ADDENDUM 03

Community Crisis Center
Helix Project No.24001.00

Issue Date: 7.28.25

A901

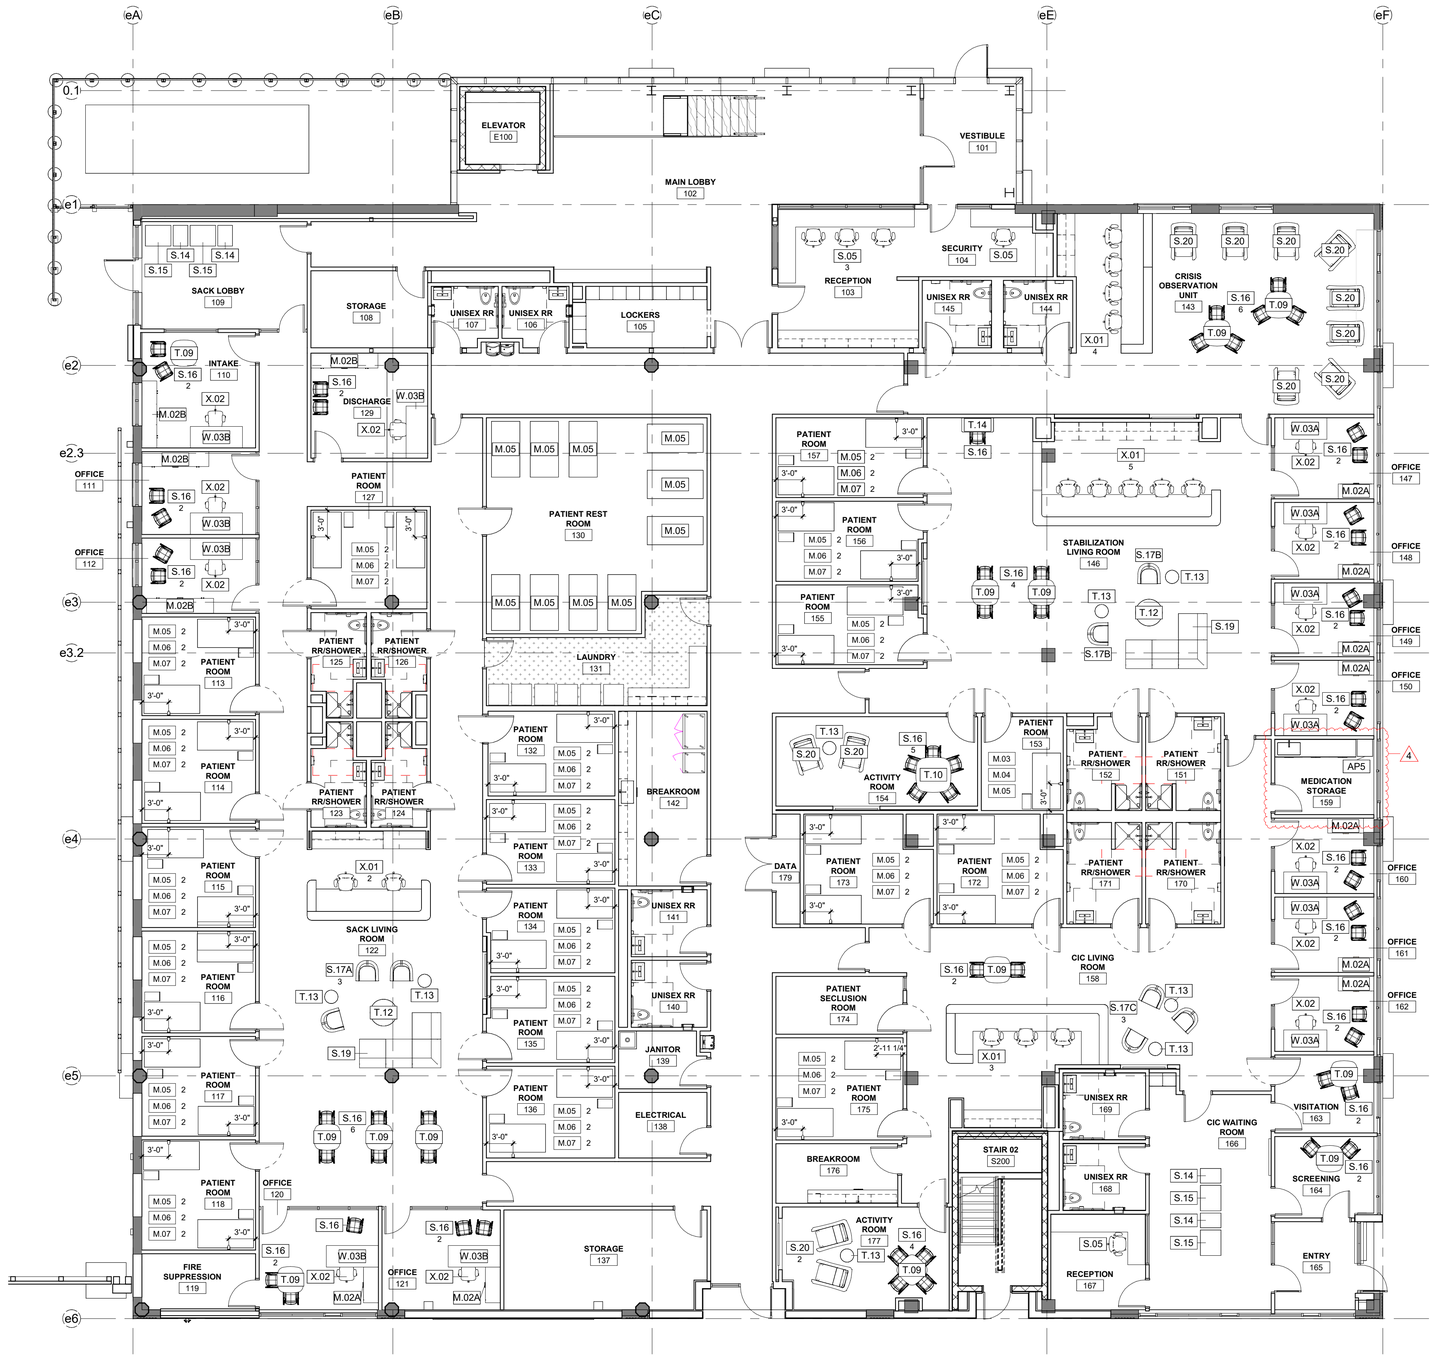
A901 - LEVEL 01 FFE PLAN
1. **REMOVE** furniture in room 159.
2. **REVISE** room 159 to be Medication Storage.
3. **REVISE** furniture in room 121 to workstation, guest chairs, and storage unit.

A902

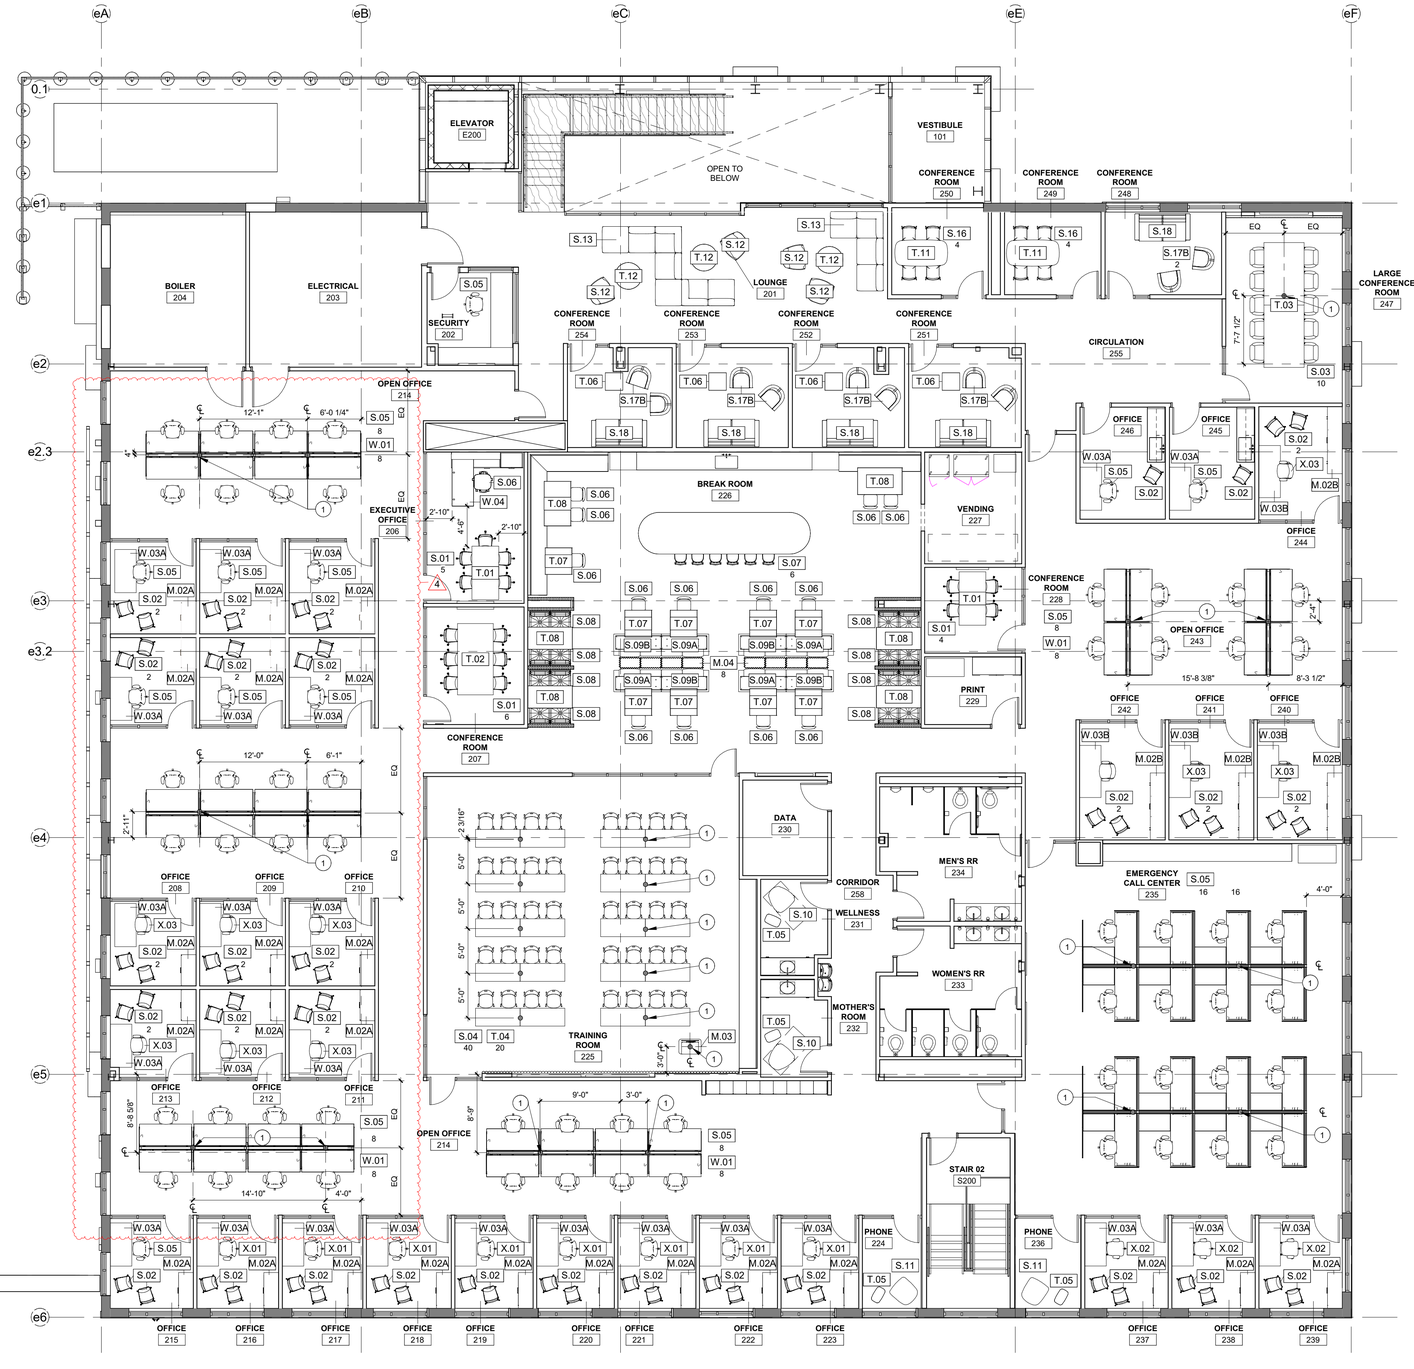
A902 - LEVEL 02 FFE PLAN
1. **REVISE** floor box location at Open Office 214.
2. **REVISE** workstation locations at Open Office 214.
3. **ADD** workstations and furniture to Offices 259 – 264.
4. **REVISE + REMOVE** floor boxes at west side of open office.

BELOW FLOOR PLUMBING PLAN
P100

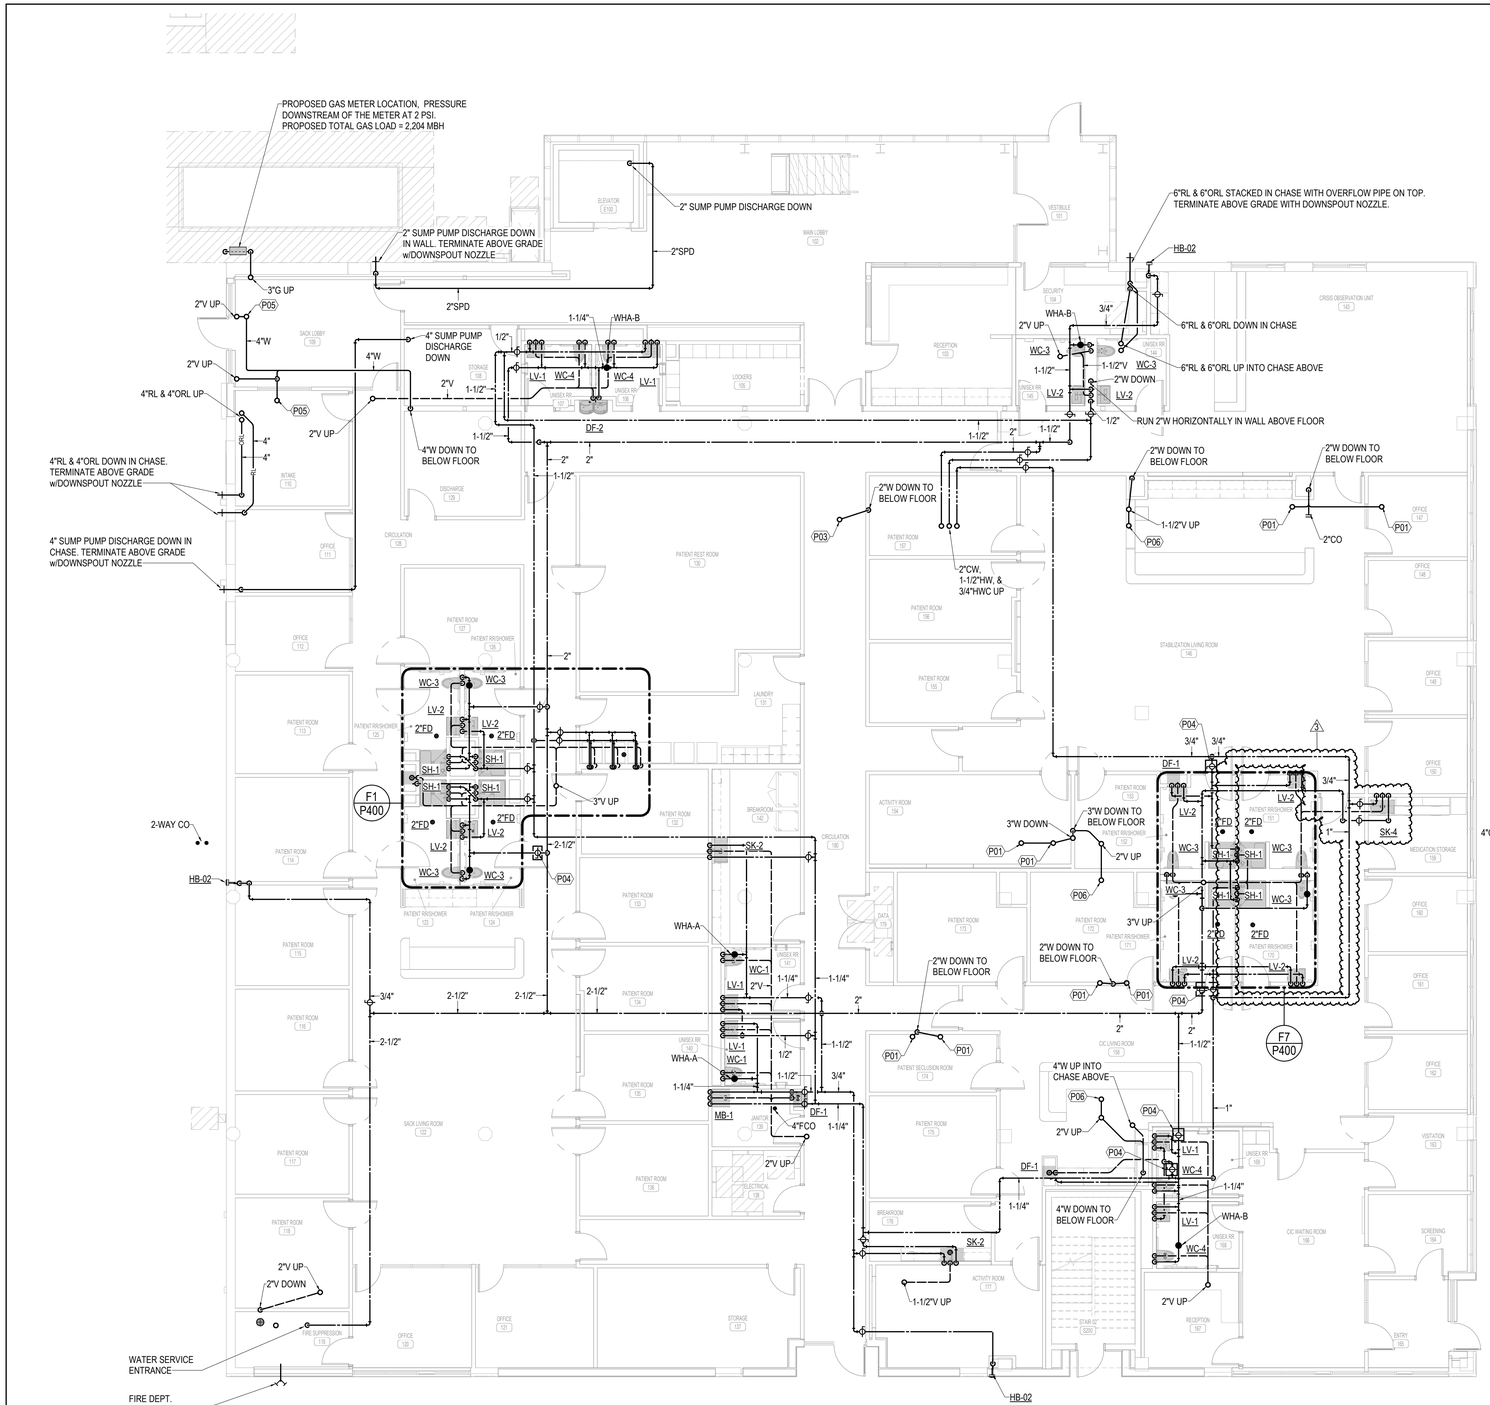
P100 – BELOW FLOOR PLUMBING PLAN
1. **ADD** waste piping for new sink in Med Storage room.

P101

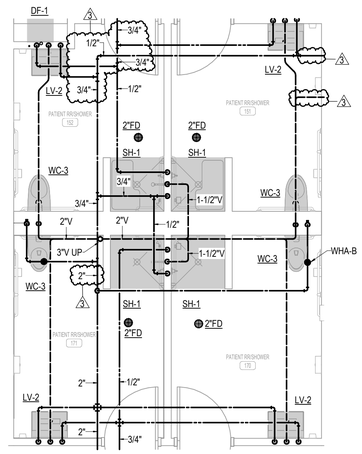
P101 – LEVEL 01 PLUMBING FLOOR PLAN
1. **REVISE** piping as required for new sink in Med Storage room.

M101

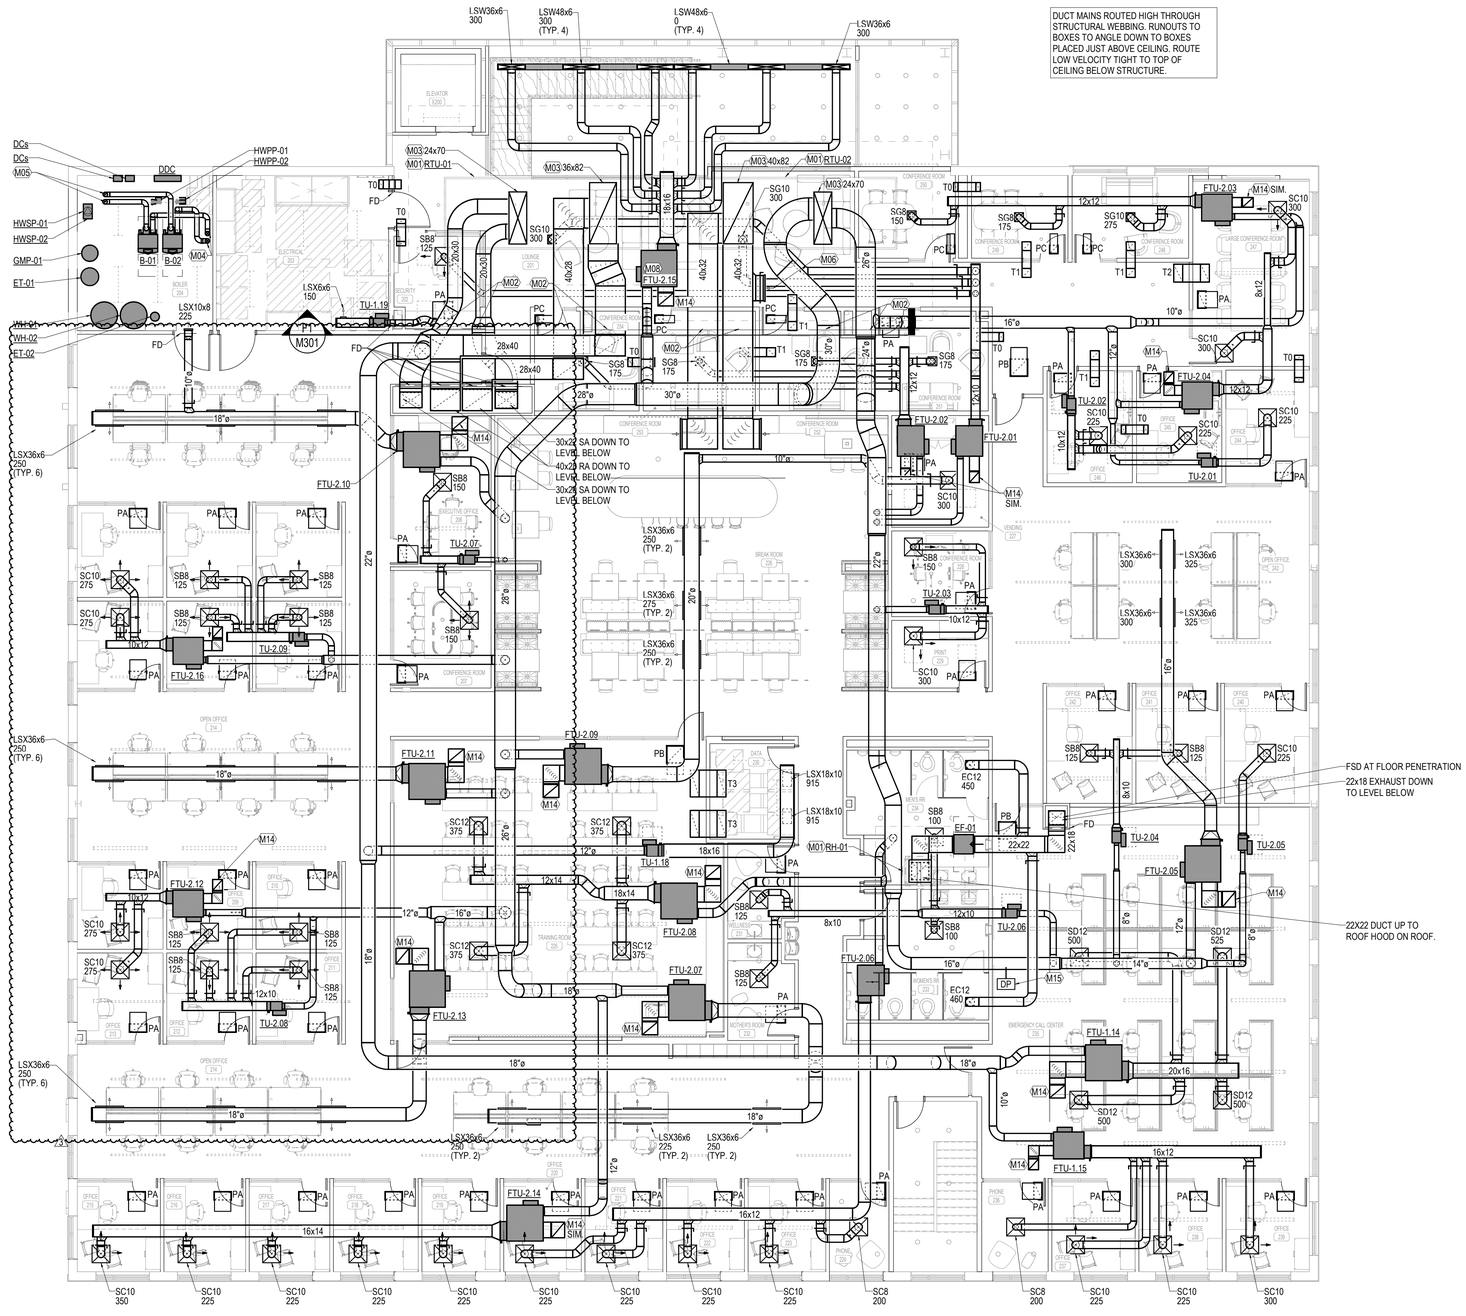
M101 – LEVEL 01 – MECHANICAL FLOOR PLAN
1. **ADD** new TU-1.20 to serve new med storage room.

M102

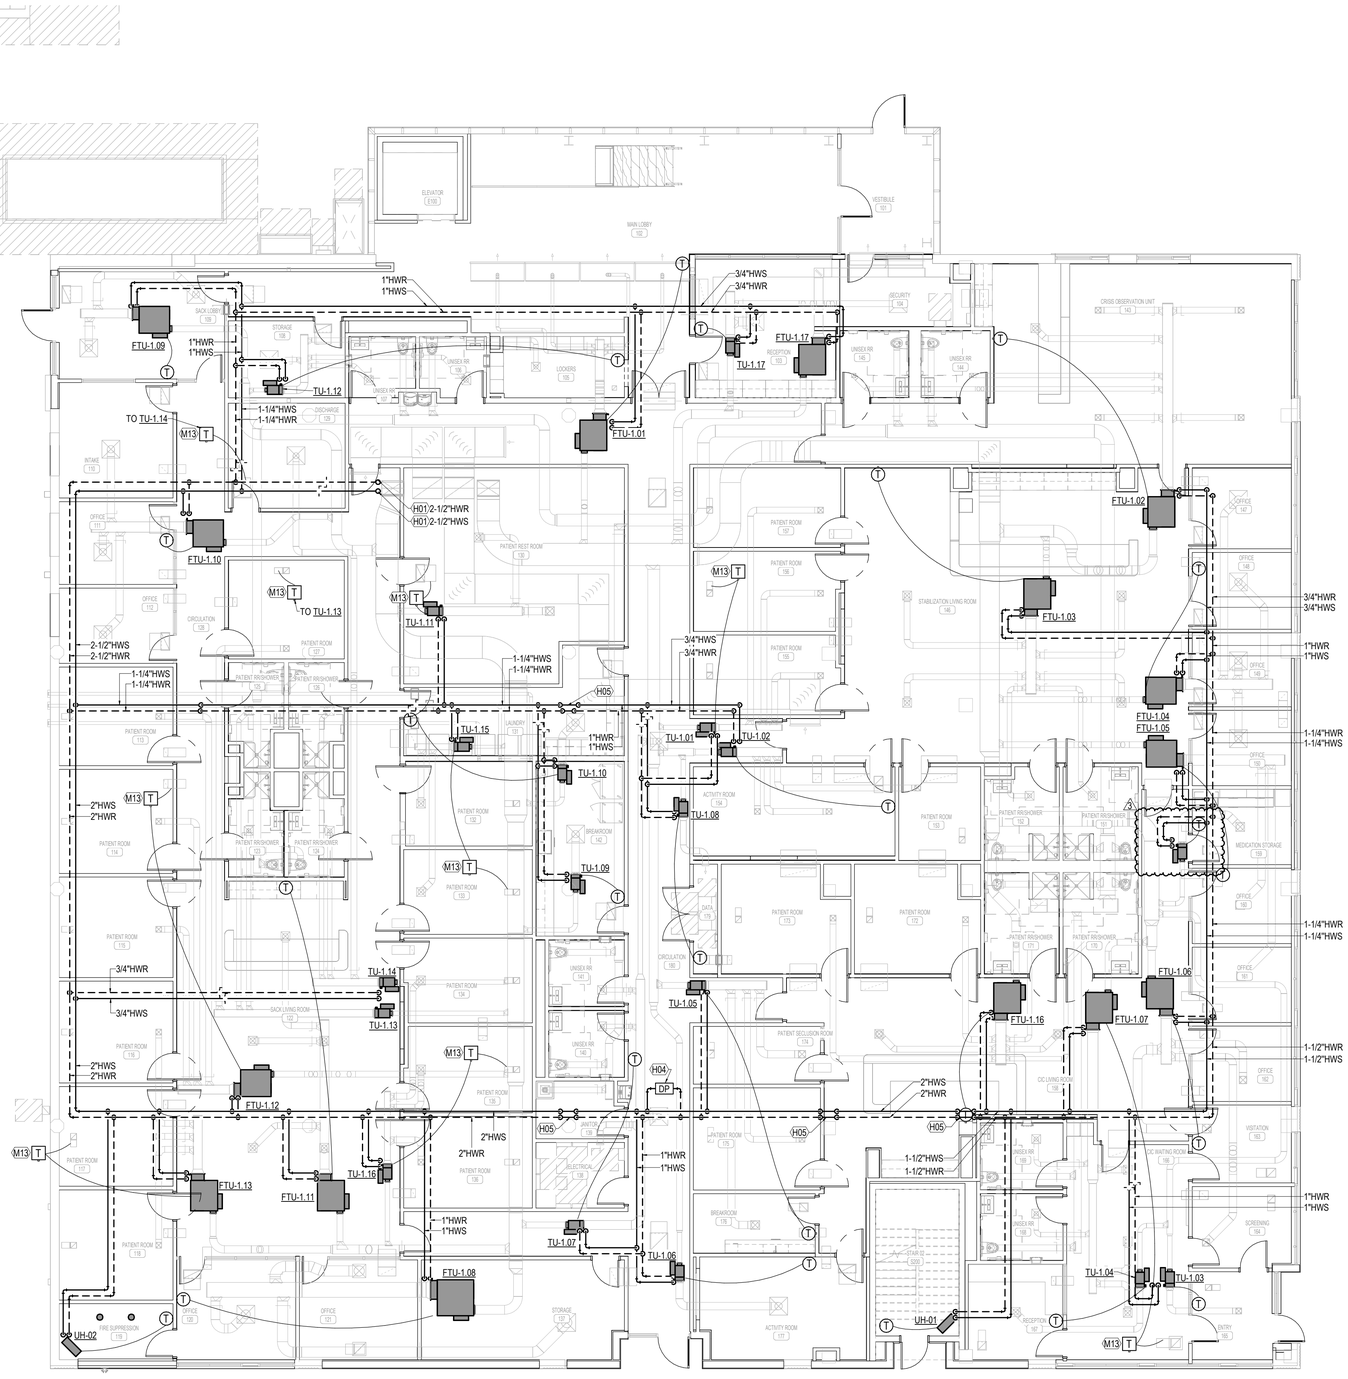
M102 – LEVEL 02 – MECHANICAL FLOOR PLAN
1. **REVISE** ductwork as required for new floor plan. This included the addition of a new terminal unit and fan terminal unit as well as reselection of existing ftu's.
